# **WRITTEN STATEMENTS**

**28 January 2021**

**Planning and Amenity Delegated  
Committee Meeting**

Figure 3: POS of Unit 3

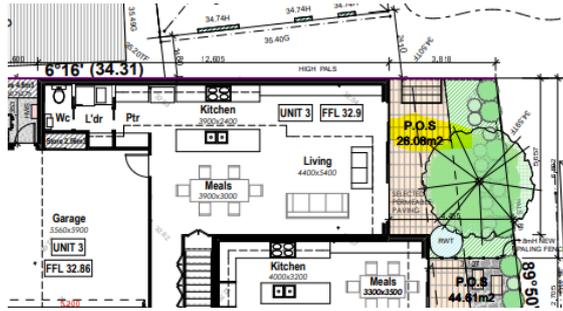
- The secluded private open space of Unit 3 does not meet the recommended areas of 40 square metres of total private open space pursuant to Standard B28 (Private Open Space).

Figure 4: West elevation

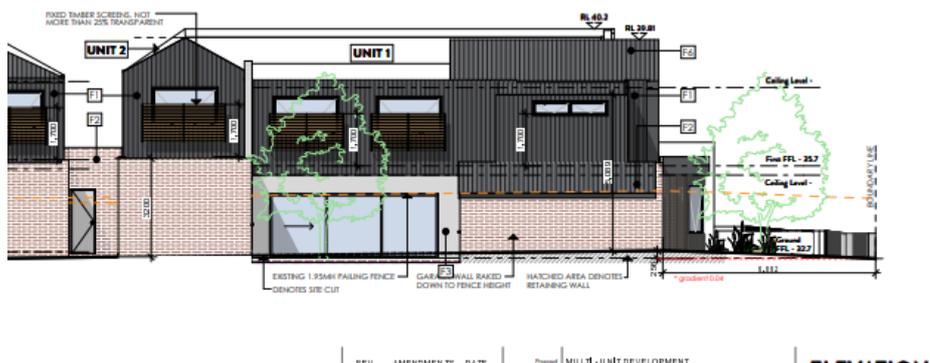
- This is particularly evident at the rear where the development provides no built form break at the upper level when viewed from the north and most important for us, from the west (Figure 1).

Figure 6: Street setback

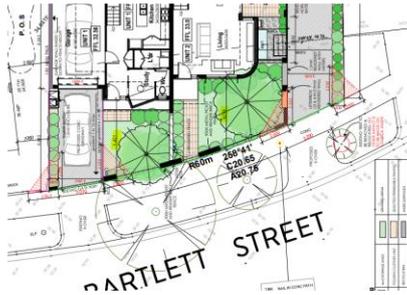
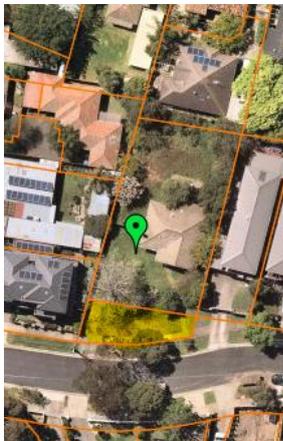
Street setback – the Precinct requirements in the ACZ1 seeks a minimum building setback of 6 metres from street frontages. The proposed development does not comply with this requirement with setbacks to the front wall of Unit 1 & 2 of less than 6 metres.
